## PROPOSED AMENDMENT DRAWING

246868-A\_A-XX-XX-DR-AX-30520 East Elevation

## NO.1 TRITON SQUARE

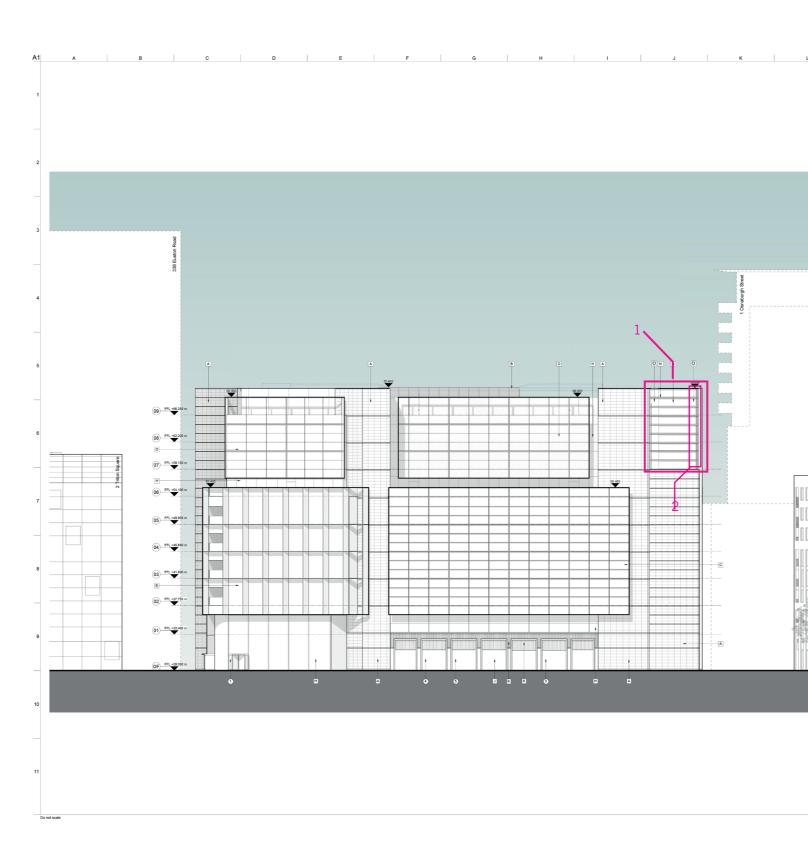
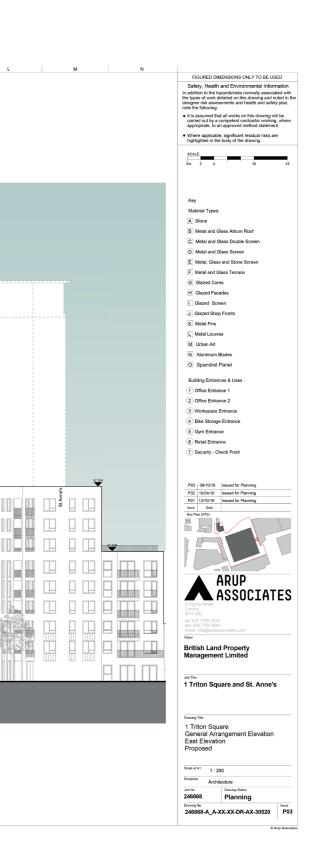
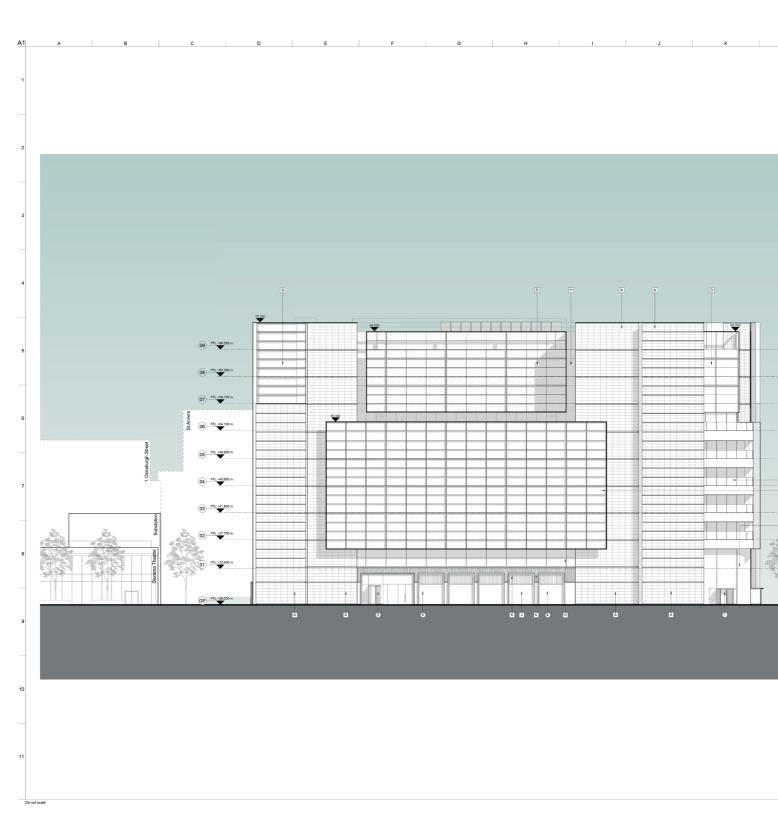
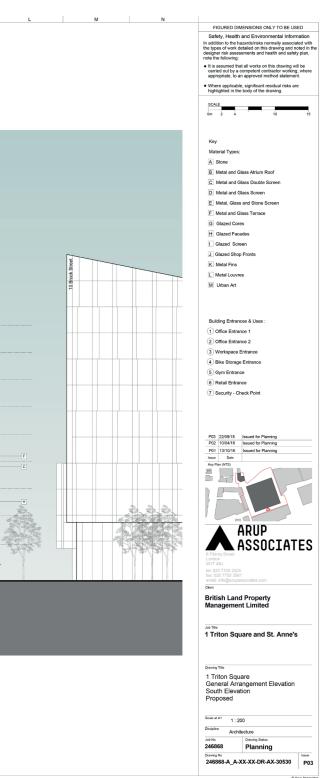
(1) A change in materials to the transoms at the top of cores from stone to anodised aluminium is proposed. Each transom is 7m wide and following design development deemed structurally unachievable given weight and aesthetic requirement for unobstructed panoramic glazing panels. This affects 6 of the 10 transoms at the top of each core. The remaining 4 are natural anodised aluminium as approved.

(2) Introduction of additional mullion to separate back painted glass spandrel panel from vision glazing - note spandrel panel hides steel column behind.
